SI 2010/1

SERVICE INFORMATION
to all distributors, owners

Use of appropriate Oil Pressure Sensors

**Applies to all Pipistrel aircraft equipped with the
Rotax 912 engine series.**

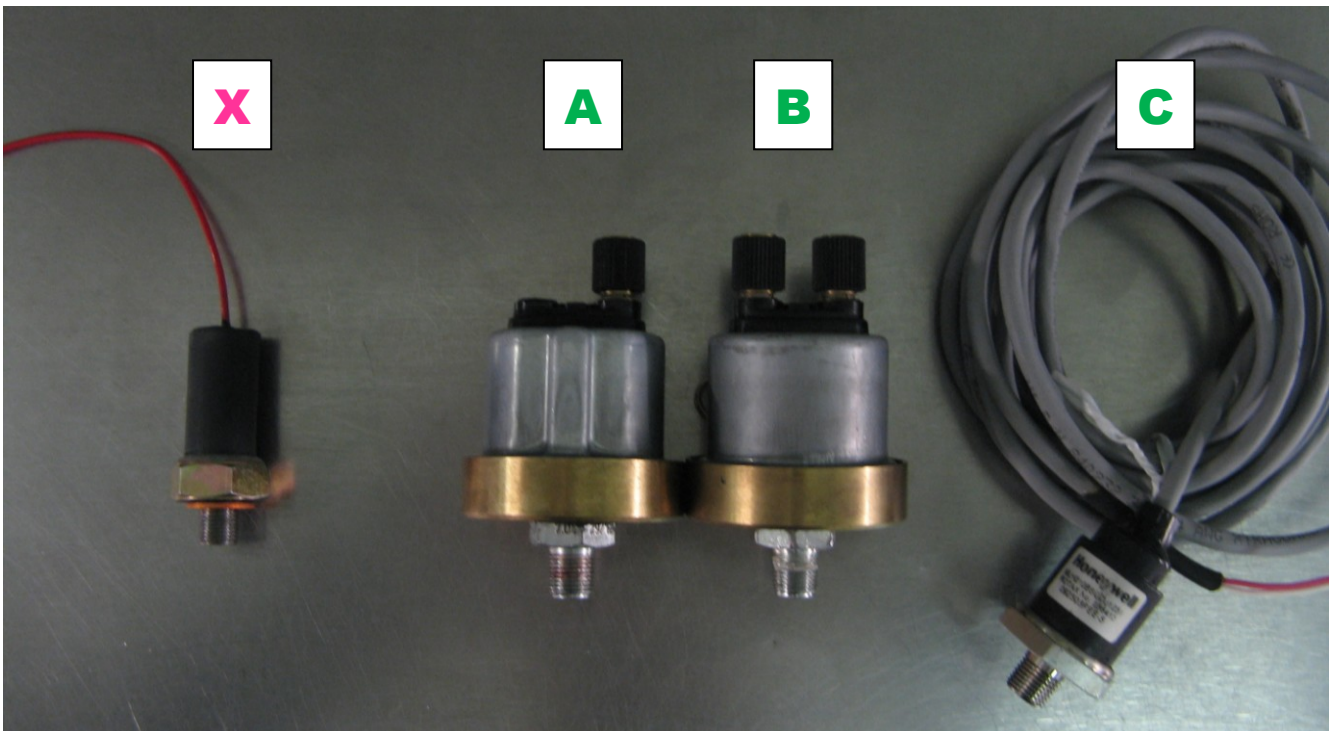
NOTE: the ONLY reliable way of determining whether your sensor needs replacement is by visual check. The sensor marked with **X** must be replaced due to a possible development of an oil leak, as described and mandated by the Service bulletin SB10. It is recommended that all owners verify that they are not using such a sensor (oil pressure switch type) at the moment, as it may have been installed during the regular servicing of the Rotax 912 engine.

WARNING! The sensor marked with **X** must be replaced immediately.

It can be replaced by any of the **A**, **B** or **C** sensor types. Based on our experience each of the sensor types has its advantages and disadvantages, therefore we are providing the following information and recommendations:

If you are currently operating the aircraft with the sensor **X**, you need to replace it immediately as per the Service Bulletin SB10. You yourself can decide which of the sensors **A, B or C** you will use in the future. The purpose of this Service Information is to assist you with choosing the most appropriate sensor for your aircraft, based on our compatibility research and experience with reliability.
